Project Name: Bernheim Middle

Change Order #KES-0005 - RFP-19

REQUEST FOR PROPOSAL

PROJECT:	Bernheim Middle School Renovation Shepherdsville, KY	REQUEST FOR PROPOSAL NO.:	19
OWNER:	Bullitt County Public Schools 1040 Highway 44 East Shepherdsville, KY 40165	DATE:	13-Jun-2024
TO CONTRACTOR:	Calhoun Construction Services, Inc. 7707 National Turnpike Louisville, KY 40218	ARCHITECT:	Studio Kremer Architects 1231 S Shelby Street Louisville, KY 40203
		ARCHITECT'S PROJECT NO.:	2022-36 BG# 23-051

title / description:
TEACHER RESOURCE ROOM
project no.: 2022_36 sketch no.:
date: 05/12/2024
drawn by: SBSS
checked by: CMV
scale: 3/32" = 1'-0" reference date:
6/12/2024 2:19:52 PM

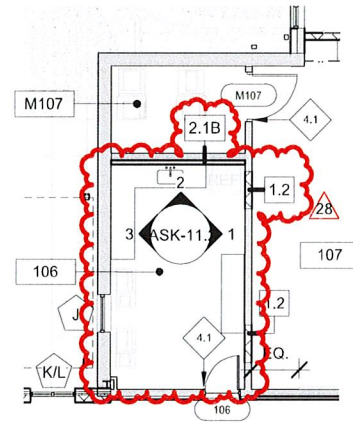
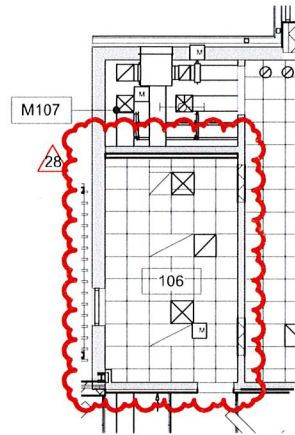
- Item 1:** REFERENCE ASK-11.1 AND ASK-11.2
- Removed Room 107A and door 107A to expand the Teachers Resource Room (Room 106).
 - Base cabinets and countertop to be located on the plan north and west wall.
 - A sink and refrigerator are to be located on the plan north wall.
 - An open countertop is located on the plan east wall.
 - A 3 5/8" stud with 5/8" has been added to the plan north wall for plumbing.
- Item 2:** REFERENCE P3.1A, P3.2A, P8.0
- Added piping to new sink in RM 106
 - Added connection for future ice maker
- Item 3:** REFERENCE M3.1A
- Modified Mechanical layout due to room expansion
- Item 4:** REFERENCE E3.1, E4.1, E7.1
- Modified lighting layout due to room expansion.
 - Modified electrical outlet locations due to casework addition in RM 106
